A1 in Northumberland: Morpeth to Ellingham

Scheme Number: TR010059

6.38 Environmental Statement Addendum: Stabilisation Works for Change Request

**Environmental Statement Addendum:
Stabilisation Works for Change Request**

Drawing title
FIGURE 1 ENVIRONMENTAL STATEMENT ADDENDUM STABILISATION WORKS FOR CHANGE REQUEST

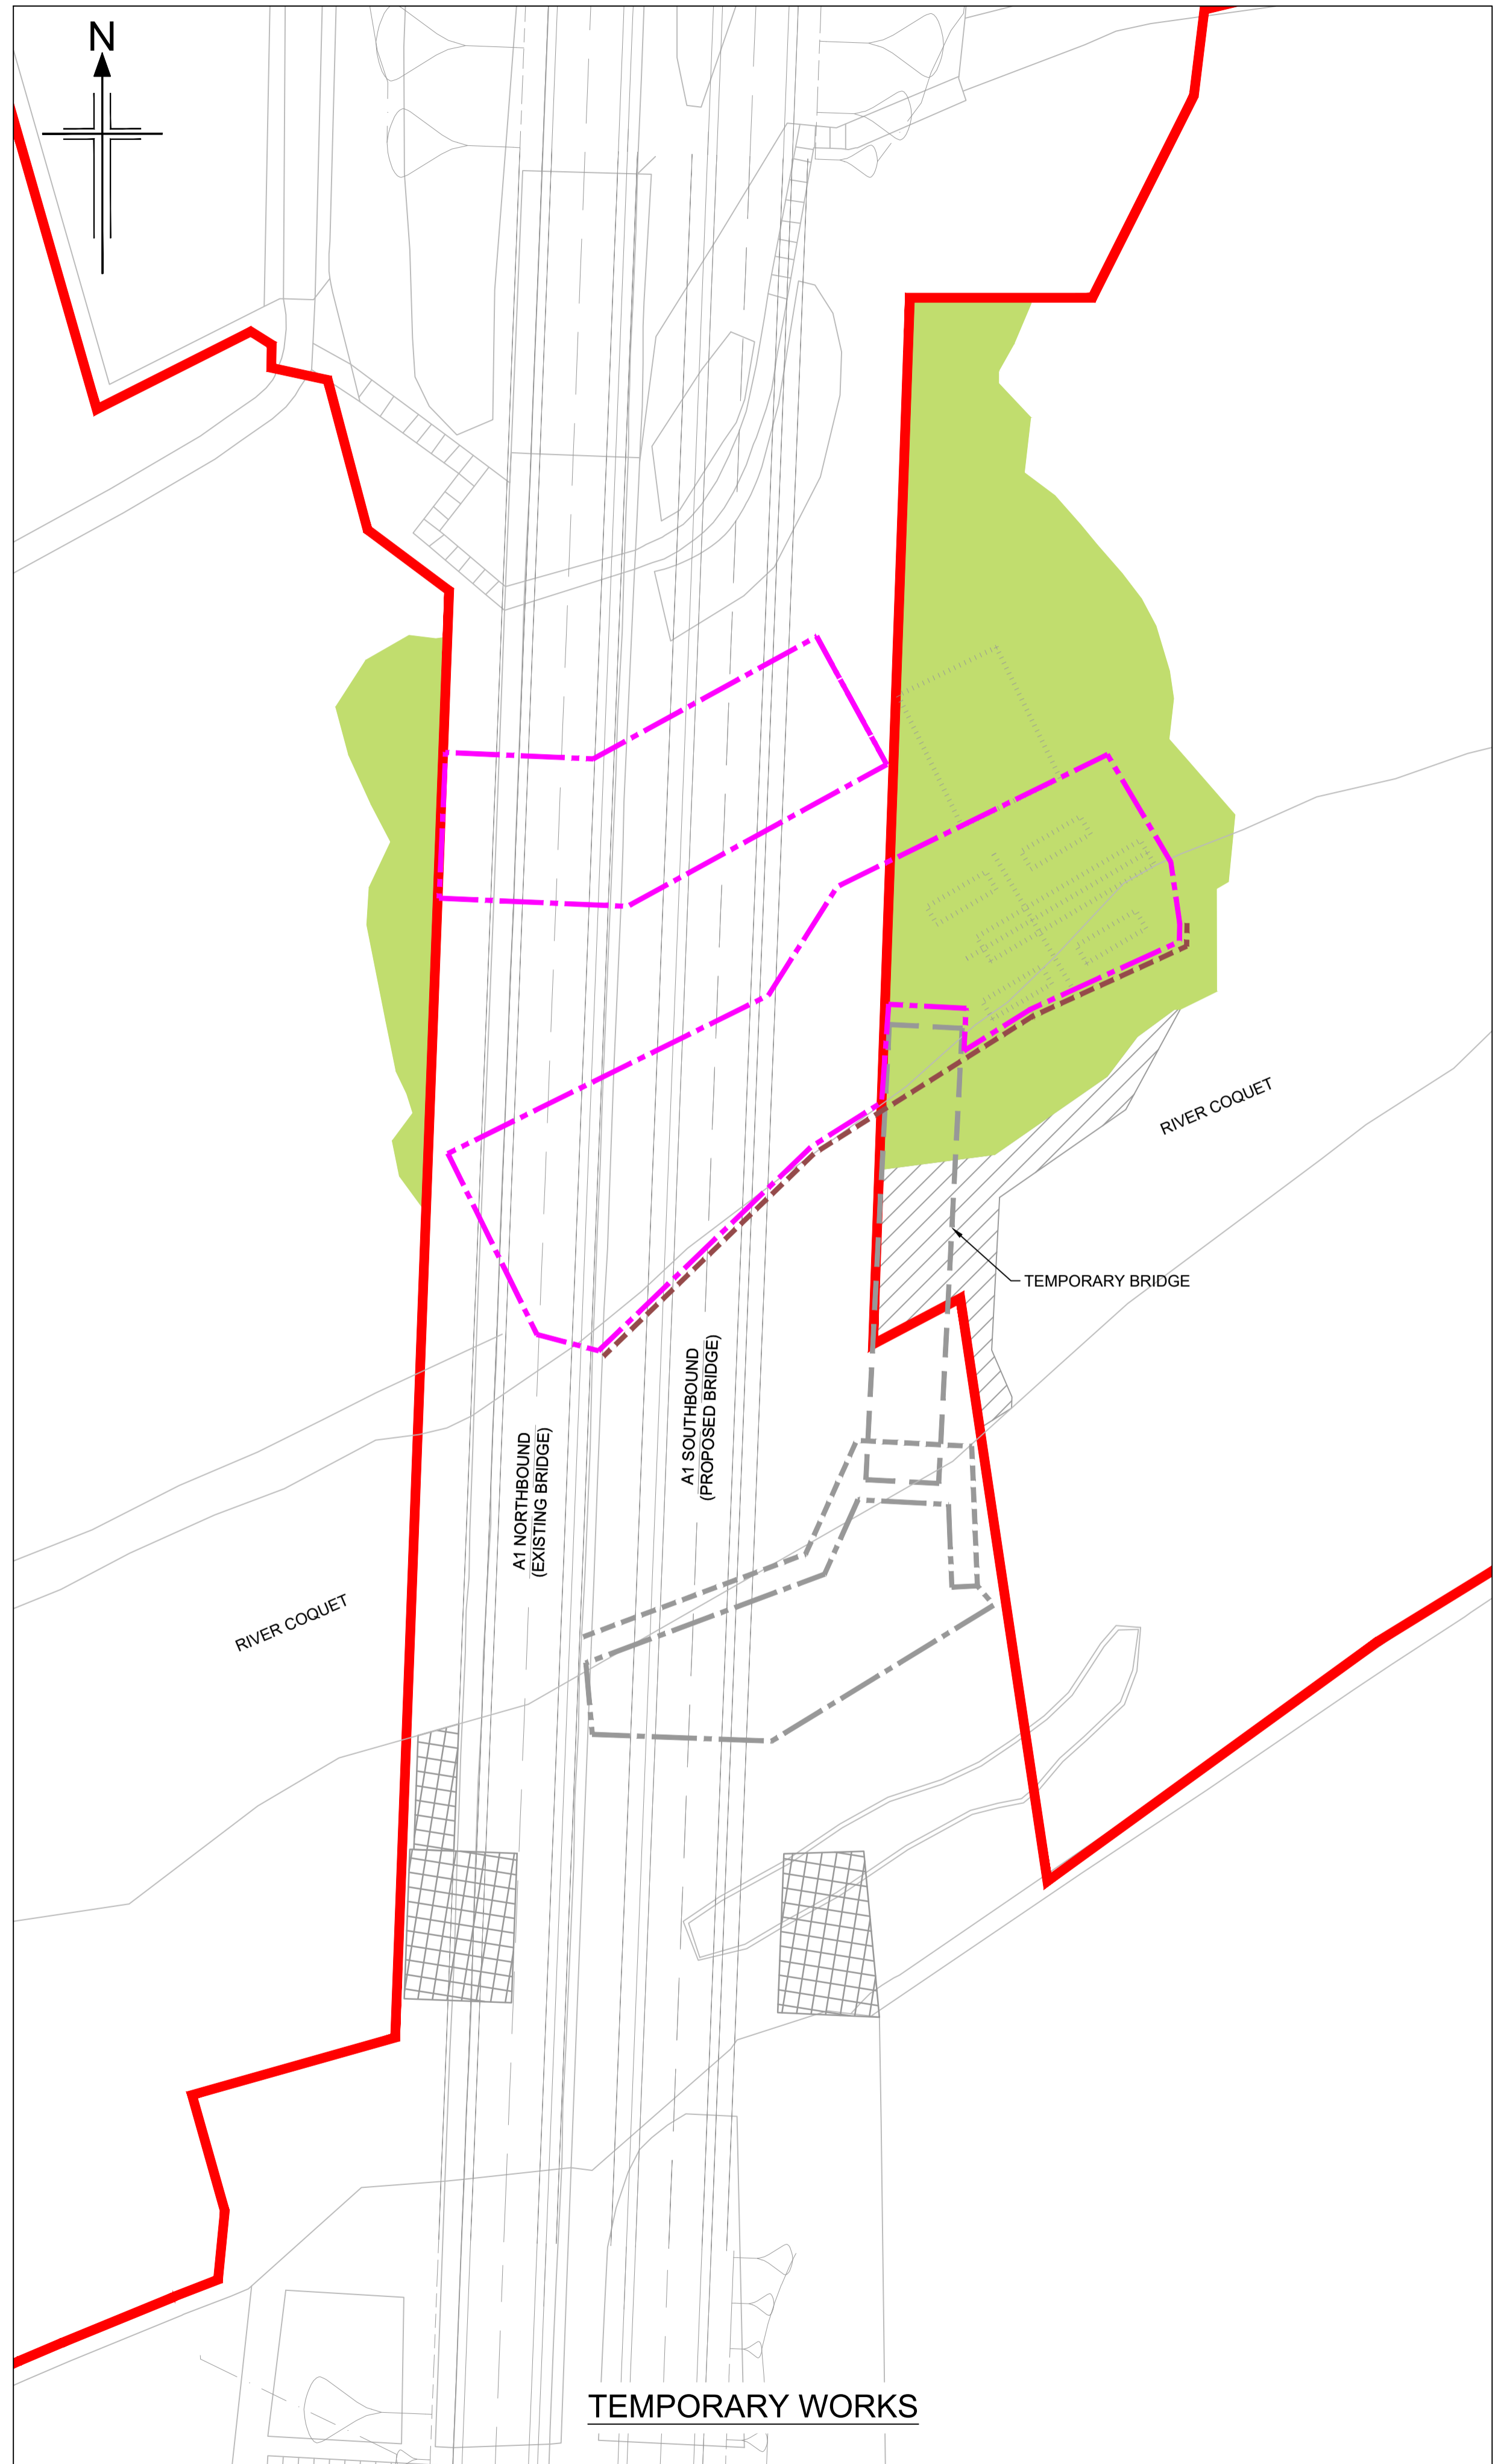
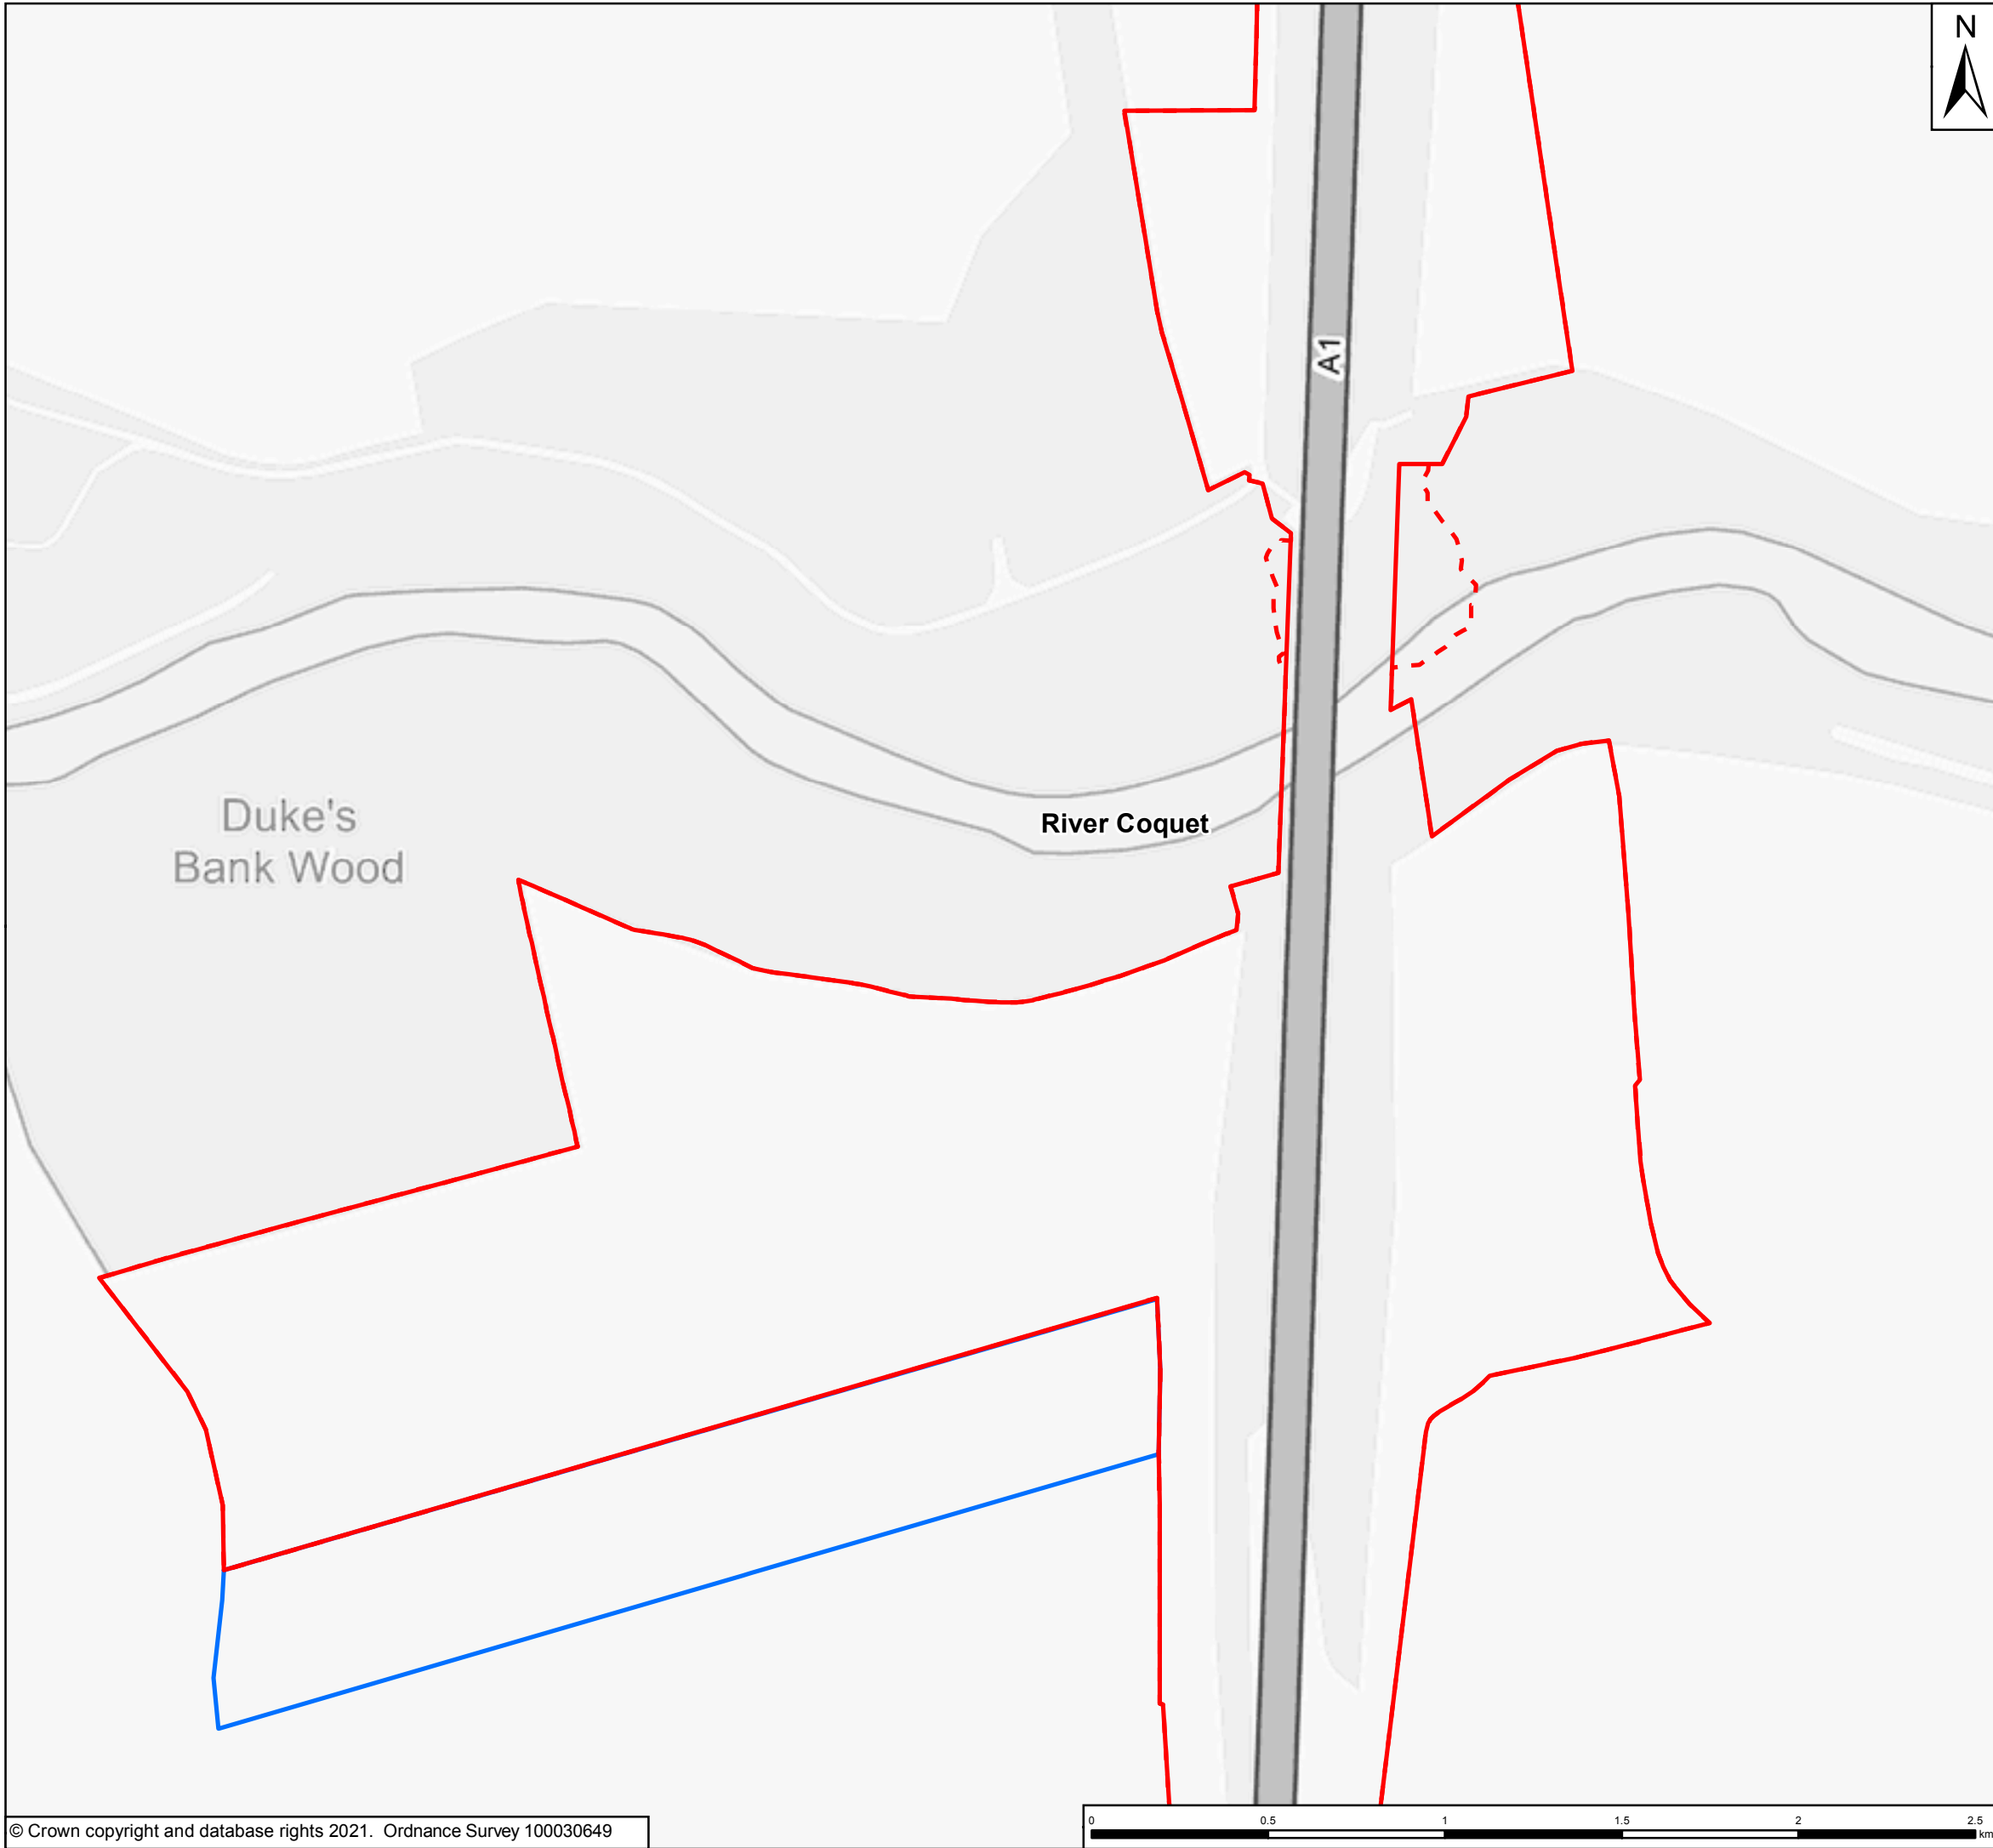
- 2.4.3. The Stabilisation Works would be required on the north bank of the River Coquet and would comprise two rows of spaced piles to the north side of the proposed pier location for the River Coquet bridge and a third row to the south side as shown in the **Figure 1: Stabilisation Works in Appendix A: Figures** of this ES Addendum. All the piles would be concrete and approximately 600 mm in diameter and indicatively 14 m in length.

- 2.4.7. A reasonable environmental worst case scenario has been used for the assessment presented in this ES Addendum. The worst case scenario for the scour protection is 86 m of scour protection on the north bank, with 62 m of rock armour plus an additional 24 m of green-grey bank protection at the downstream end. This equates to a total of 1,200 m³ (or 2,640 tonnes) of rock armour and 93 m³ of grey-green bank protection (e.g. a geotextile turf type solution) The location of the scour protection is shown on **Figure 1: Stabilisation Works** in **Appendix A: Figures** of this ES Addendum.

- 2.6.4. The Stabilisation Works would involve the creation of a dry area to allow reparation of the riverbed to accept river training works. The location of the temporary training works are shown on **Figure 1: Stabilisation Works in Appendix A: Figures** of this ES Addendum. The installation of temporary river training works is expected to take approximately four weeks and would likely be in place for approximately 16 months (July 2022 until November 2023).
